Accessibility Survey

City of Downey Emily Lane - Ryerson Avenue to Old River School Road

Date of Inspection 8/15/2017

Sidewalks : Vehicular Traffic Cross Slope

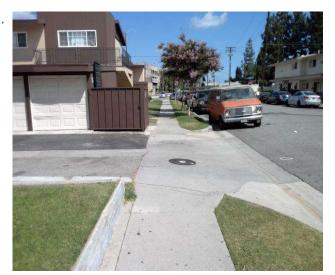
Cross slope at vehicular traffic is not compliant.

On-Site Finding 9.30 percent

Repave the surface to provide a compliant cross slope.

Recommendation Up to 2.08 percent

Sidewalks , Vehicular Traffic : Cross Walks and Detectable Warnings

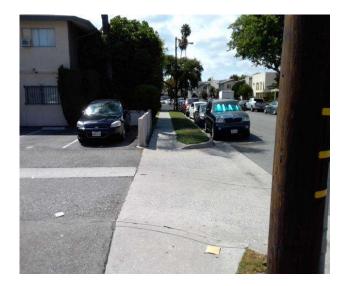
There are no detectable warnings where the pedestrian route crosses vehicular traffic.

On-Site Finding Not Found

Provide detectable warnings.
